ADDENDUM TO PLANNING COMMITTEE AGENDA

Application Number: AWDM/1518/17

Site: 22 Lyndhurst Road Worthing West Sussex

Proposal: Demolition of existing building and erection of three to four-storey block of 30 flats comprising 4no. one-bedroom, 25no. two-bedroom and 1no. three-bedroom units all with balconies with provision of bin and cycle storage and undercroft access to car parking area, new vehicular access onto Lyndhurst Road and removal of trees and associated landscaping.

Figure 5.5 Car Ownership Levels by Age of Residents (Oldest in Apartment)

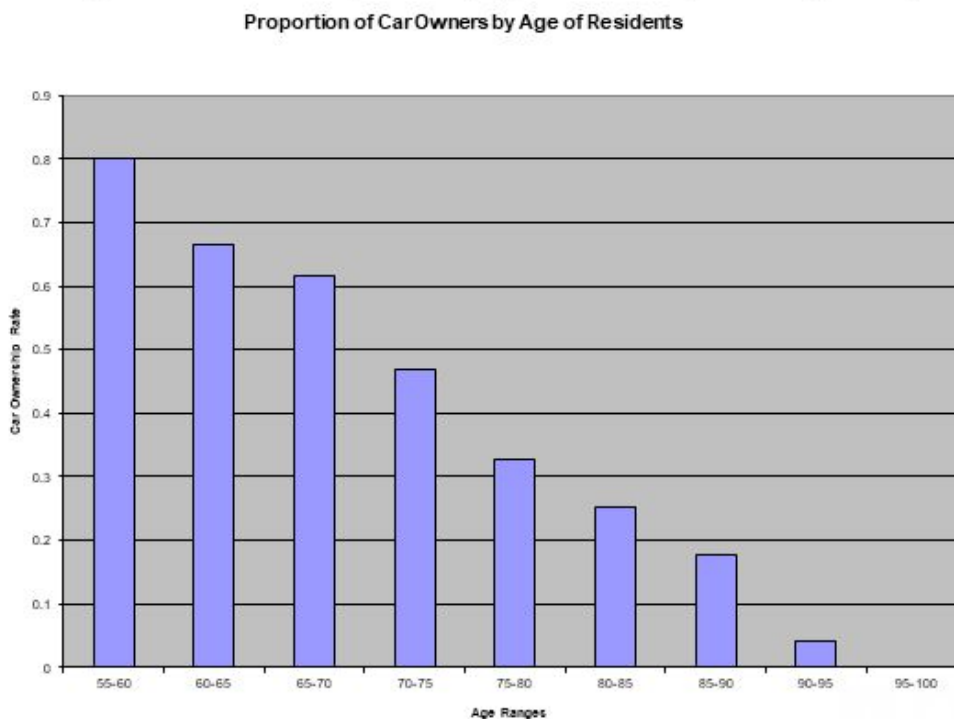
3. My research shows that car ownership declines significantly with the age of the resident. The diagram below is an extract from my PhD Thesis that demonstrates this.

Again, if the age of residents tends towards the younger end of the scale, the car ownership may well be significantly higher. The figure included in my report relates the age profile of the residents of the McCarthy and Stone development model, which would appear to be very different to the current proposal.
